**MAG Standard Specifications and Details Committee**  
**TENTATIVE AGENDA**  
**June 3, 2015**

MEETING MINUTES FROM THE  
MARICOPA ASSOCIATION OF GOVERNMENTS  
STANDARD SPECIFICATIONS AND DETAILS COMMITTEE

## 2015 PROPOSED REVISIONS TO MAG SPECIFICATIONS AND DETAILS

**Date:** June 4, 2014 Revised 2015-05-18  
**To:** MAG Specifications and Details Committee  
**From:** Robert Herz, MCDOT Representative  
**Subject:** Revisions to Sections 336, 321.10.3, 601.2.7, 601.2.10, and **Case 14-12**  
Detail 200-1

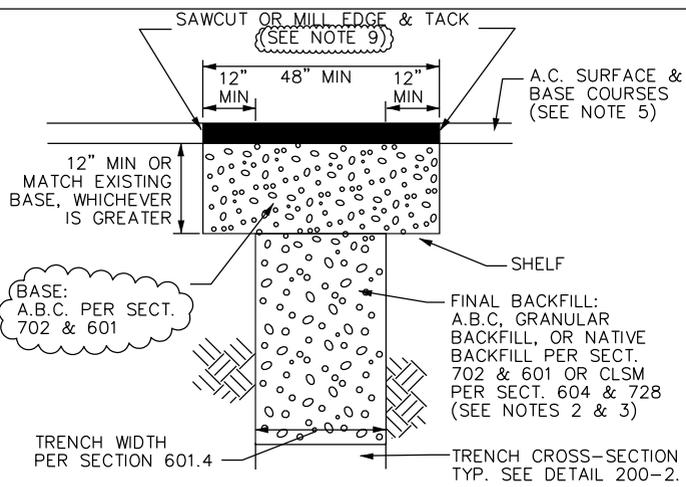
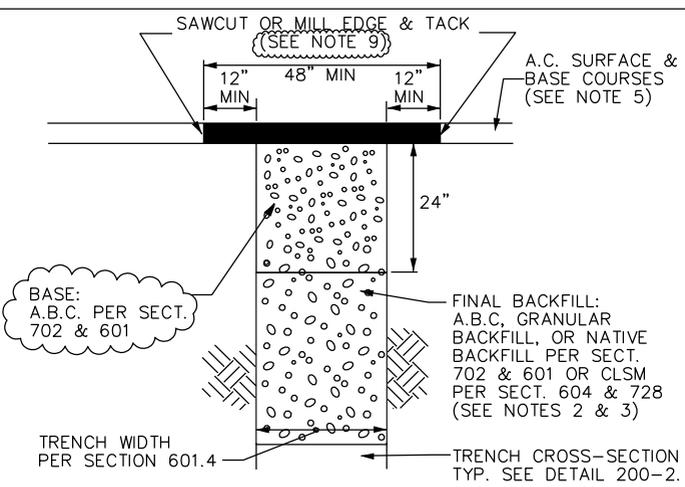
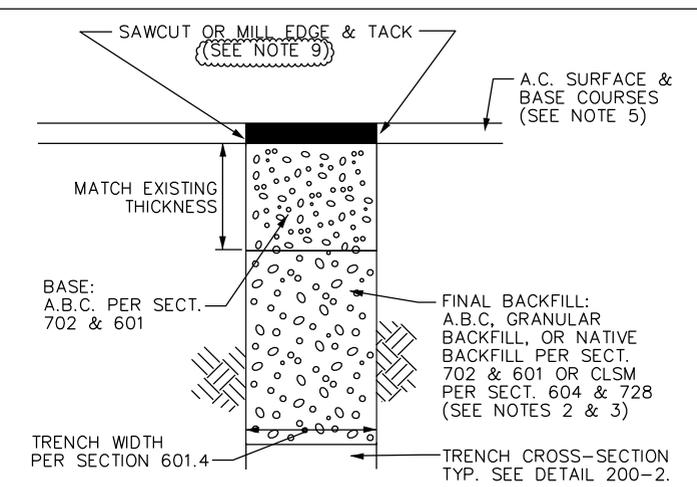
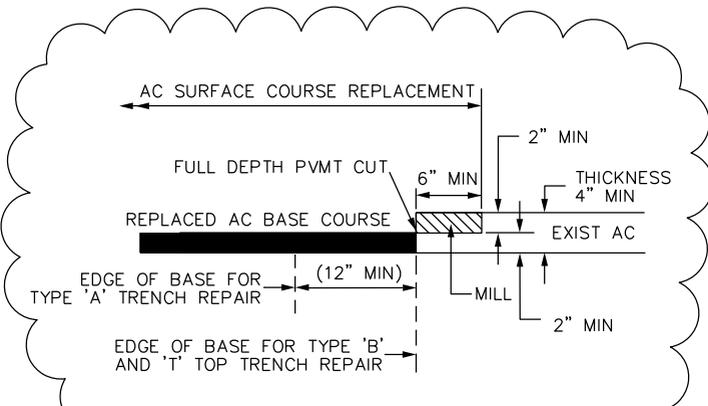
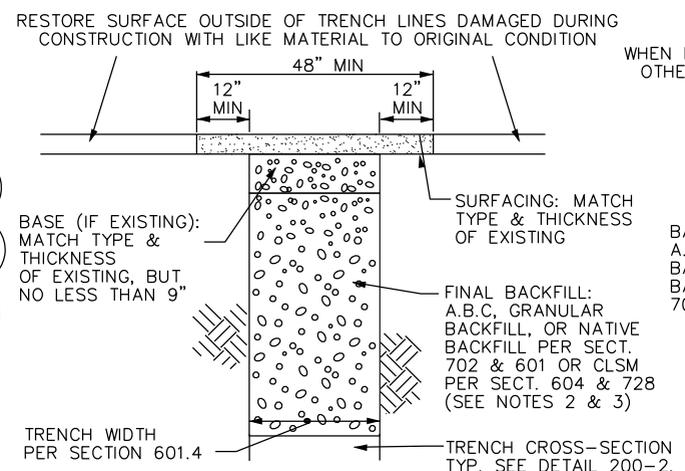
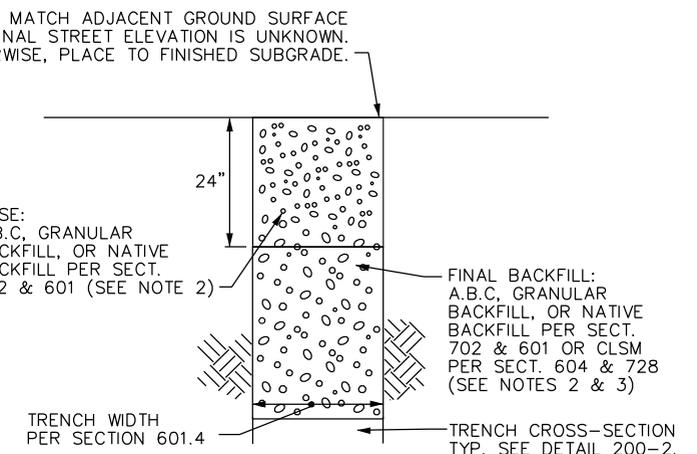
**PURPOSE:** Add pavement removal criteria to prevent full depth pavement cuts from being located within a lane wheel path and to prevent creation of narrow pavement edge strips.

1. Identified location restrictions for full depth longitudinal joints for asphalt pavement widening and for asphalt pavement trench repairs.
2. Defined vertically offset joint as an alternative for full depth sawed joint.
3. Added pavement removal requirements when replacing existing curb or gutter.
4. Added requirement for asphalt pavement edge replacement to have a safety edge or thickened edge constructed per Detail 201 except when the asphalt edge abuts a concrete curb or gutter.
5. Trenching into portland cement concrete pavement, sidewalk, or other concrete flatwork shall require complete joint to joint replacement of damaged panels. Type C Trench Repair in Detail 200-1 is to be deleted.
6. Adjusted the measurement for trench surface replacement to include extra area required to eliminate narrow edge remnants and to move full depth asphalt cuts outside of defined lane wheel paths.

Asphalt concrete roadway ~~pavement replacement~~ trench repairs shall be constructed in accordance with Type A, B, or T-Top Trench Repair of Standard Detail 200-1 and as indicated on the plans or in the special provisions.

Trench repairs for unpaved alleys, roadways, and designated future roadway prism shall be constructed in accordance with Type E Trench Repair of Standard Detail 200-1.

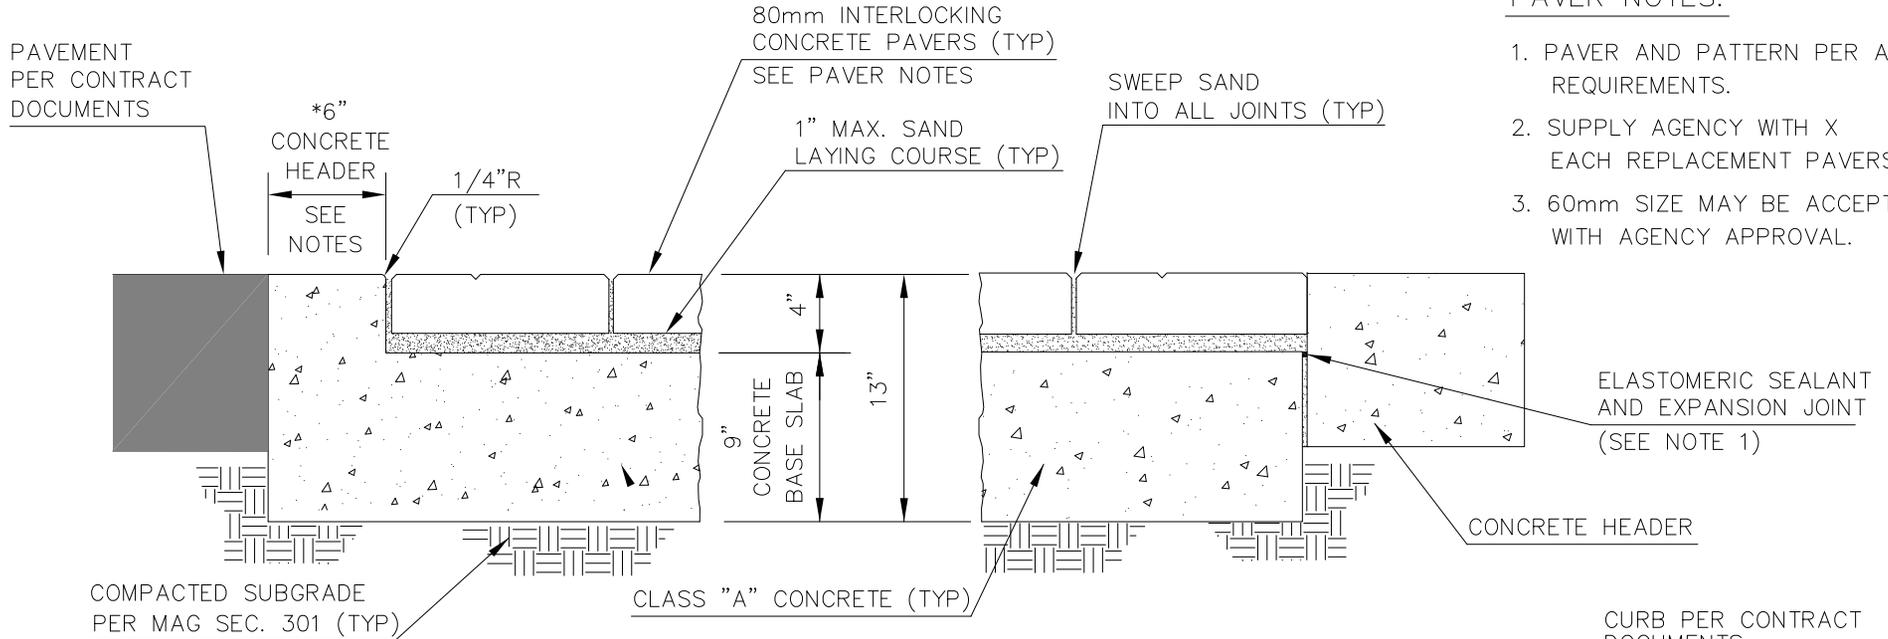
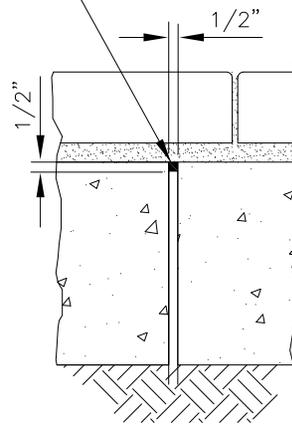
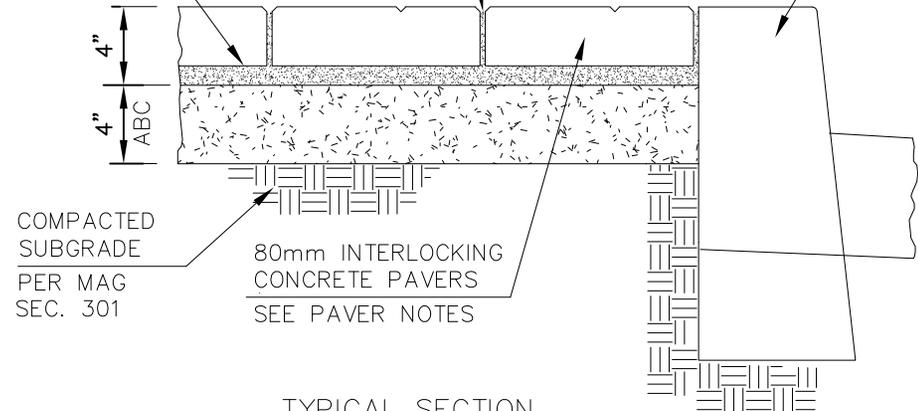
*Make revisions to Detail 225 and Section 342.* Warren White said there was no update this month. He said he needs to add a detail for non-travel areas to the current Detail 225. He said he will have an update ready for the June meeting.

1. Revision to C-225 Concrete Paver Detail to depict pavers/decorative concrete on ABC for raised medians or other non-traveled areas?
2. Revision to MAG Section 342 Decorative Pavement Concrete Paving Stone or Brick, Section 342.3 Construction Standards?

**Subsection 342.3.2 Aggregate Base Course: Delete this subsection in its entirety and replace with the following:**

The base course for decorative pavement shall consist of CLSM of a thickness specified in the plans or special provisions. 1-Sack CLSM shall be installed over subgrade soil compacted to a minimum of 95% density. The surface elevation of the CLSM shall be set to bring the 1-inch sand laying course, plus the thickness of the paving stones or bricks to the desired finished elevation of decorative pavement. The surface of the 1-Sack CLSM shall not vary more than +1/8 inch in 10 feet.
